THE ROCK COMMERCE CENTER GRADING AND EROSION CONTROL PLANS

V2_Grading and Erosion Control Plan Comments.pdf Markup Summary

EL PASO COUNTY

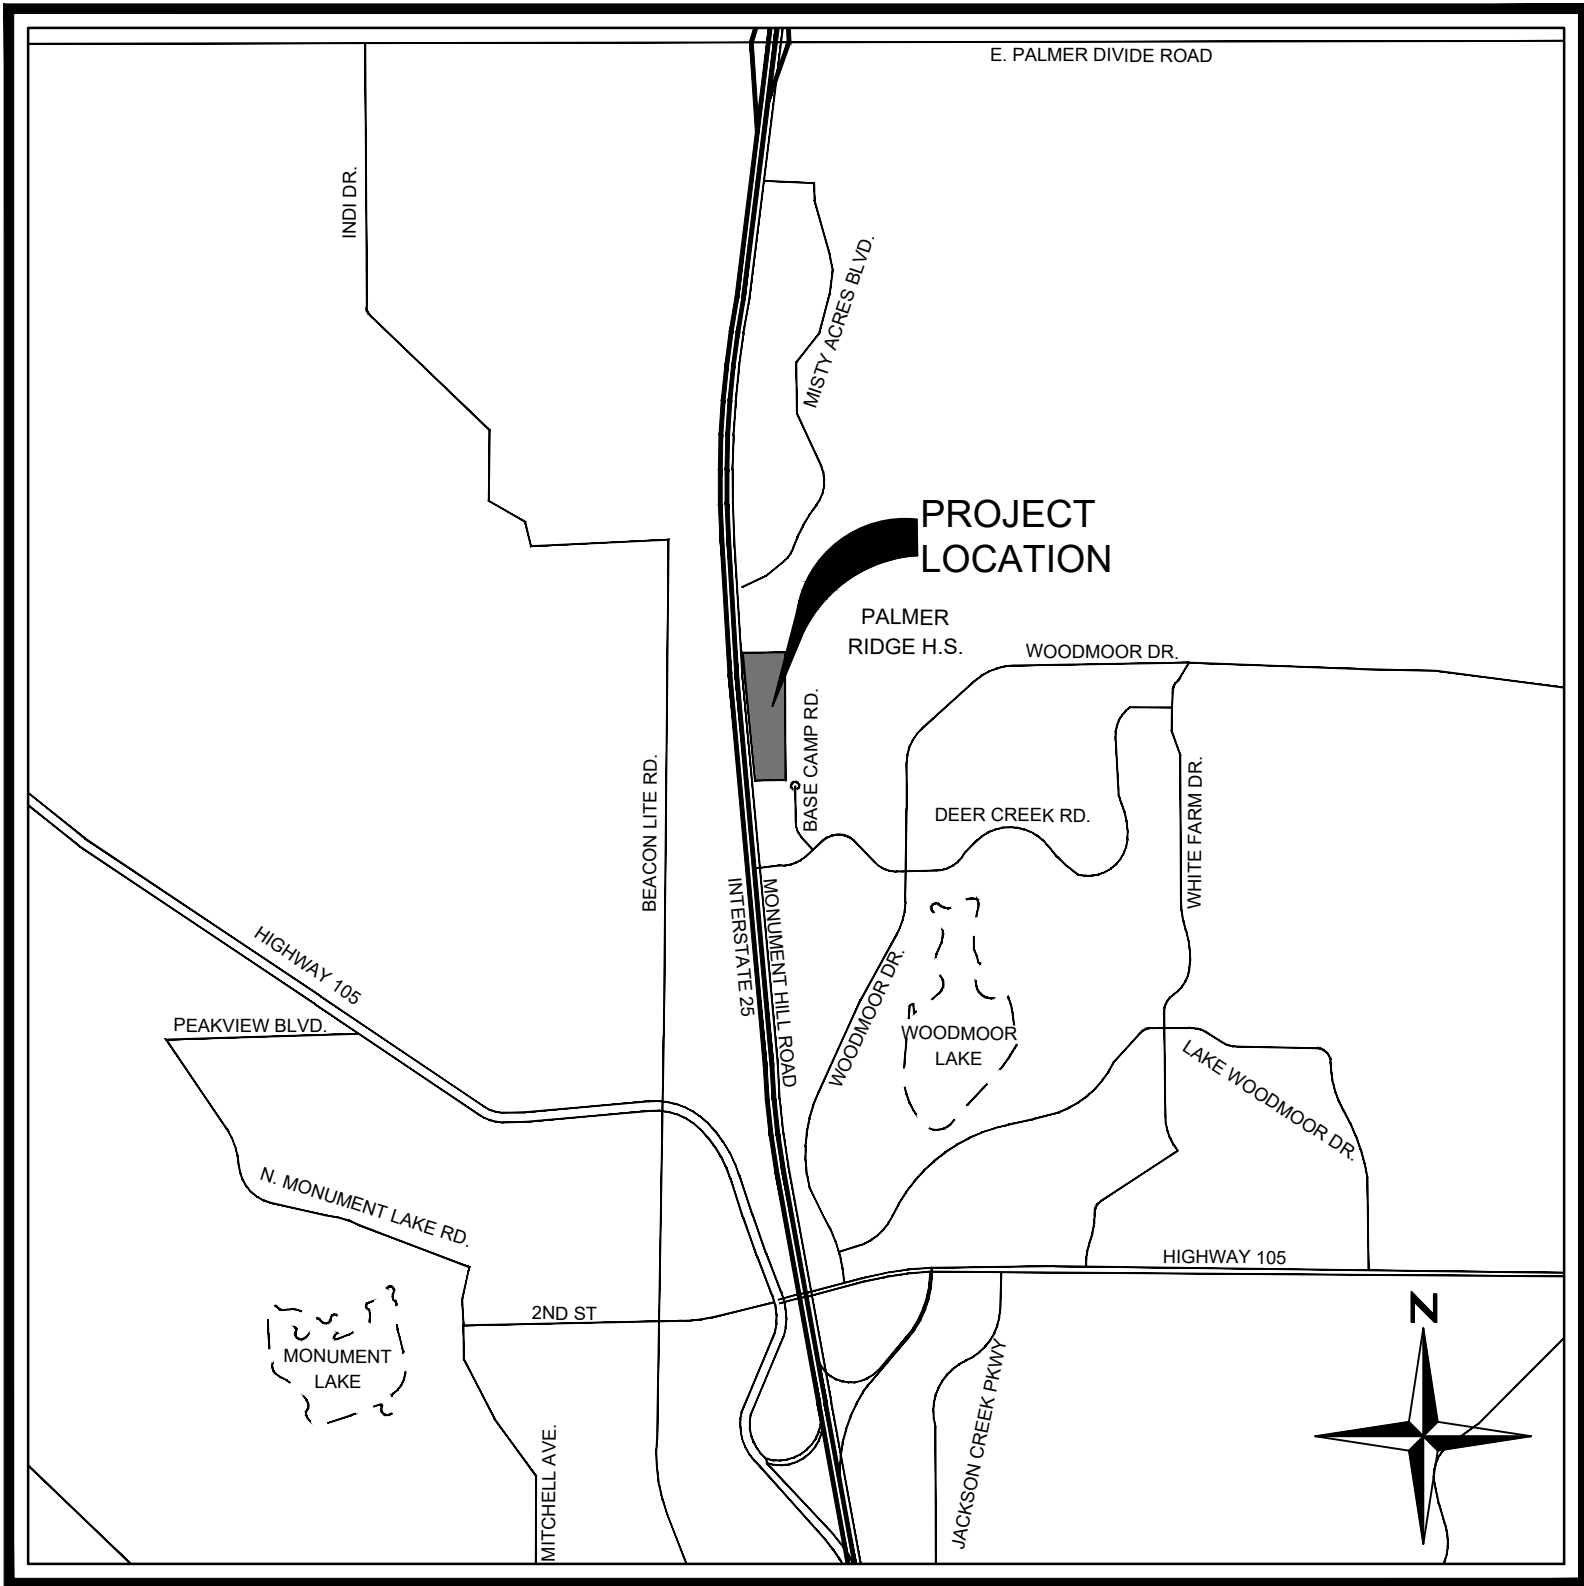
Change to Josh Palmer, PE

The County signature block was updated as requested.

THE ROCK COMMERCE CENTER
GRADING AND EROSION CONTROL PLANS
INITIAL EROSION CONTROL PLAN

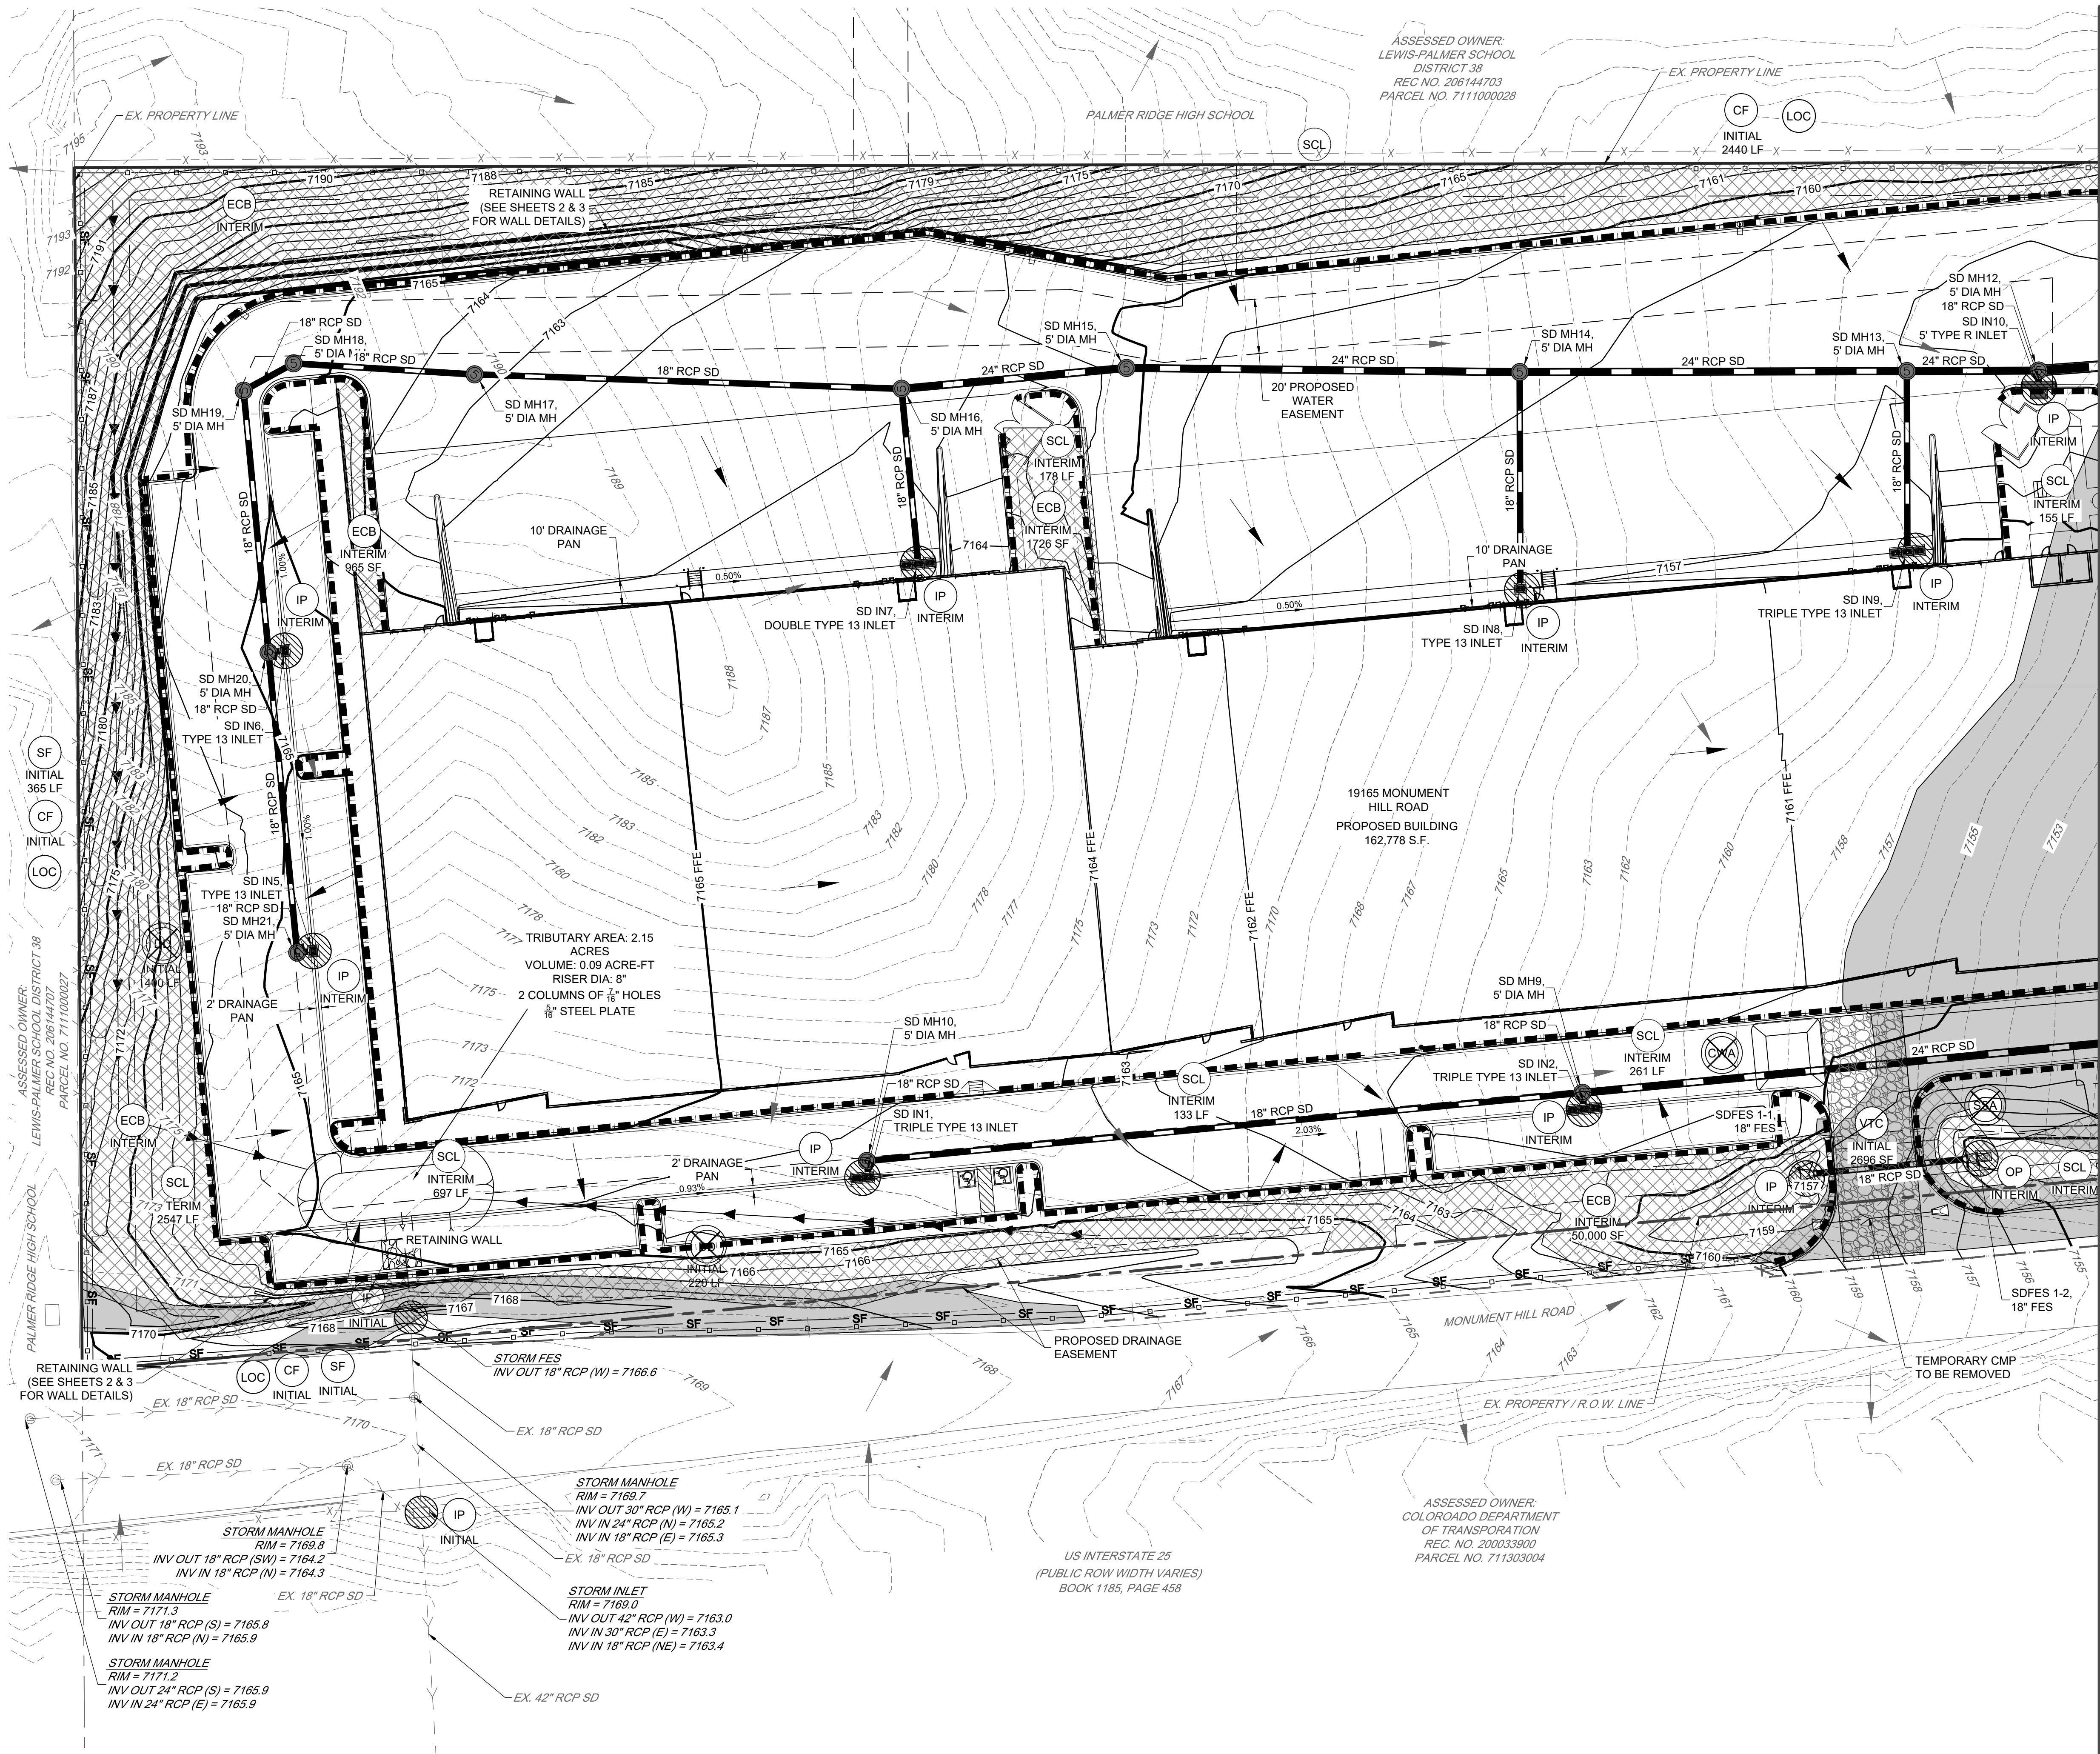
I didn't see the concrete drainage pan detail. Comment Response stated that it was on Sheet 5. I believe that is just the diversion ditch detail. Include 2' and 10' concrete drainage pan detail on this sheet.

The concrete drainage pan details were added to these sheets from the SDP Grading Plan Sheets.

THE ROCK COMMERCE CENTER
GRADING AND EROSION CONTROL PLANS
INTERIM EROSION CONTROL PLAN

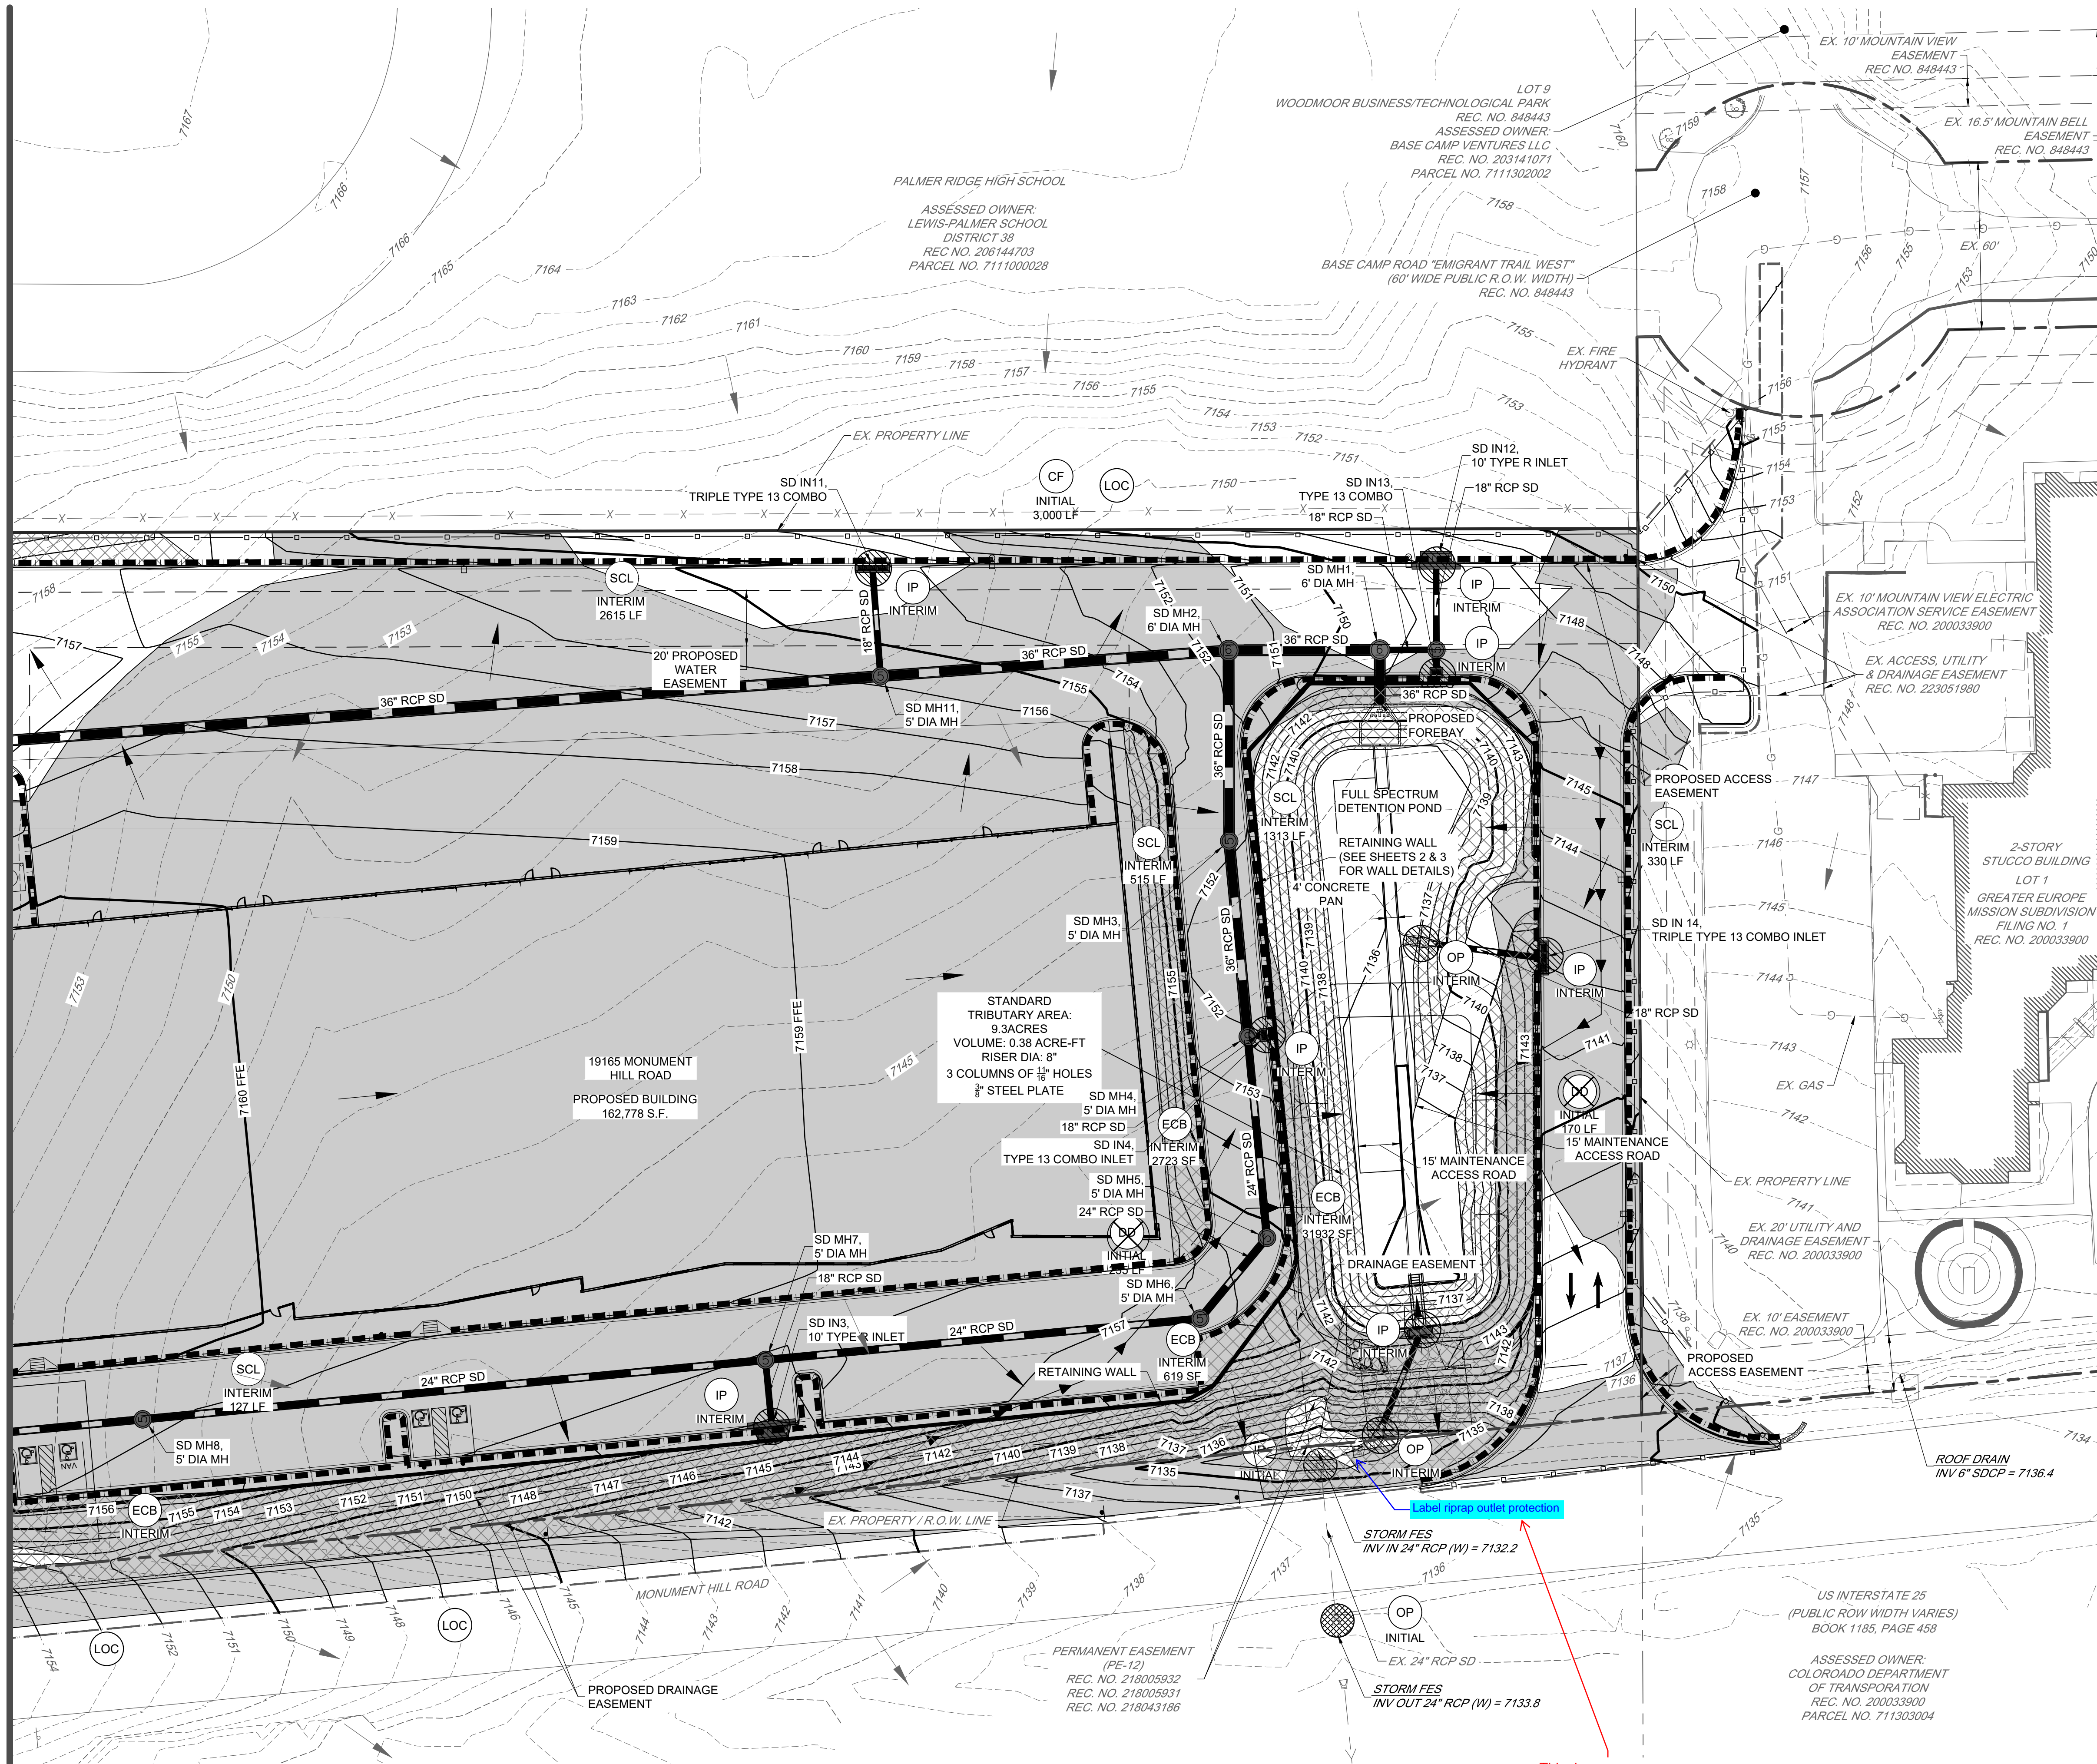
Provide pond details, including (but not limited to):
- forebay
- outlet structure
- trash rack and orifice plate details
- spillway
- trickle channel
- pond bottom
- maintenance access road
- riprap outlet protection

show final erosion control figures (seeding mulching, pavement, ECB etc.). For clarification, do not show cut/fill shading or other temporary BMPs. Unresolved.

The Pond detail sheets will be added to the Construction Documents for approval.

A final erosion control plan to show seeding, mulching, permanent ECB, and Pavement was added.
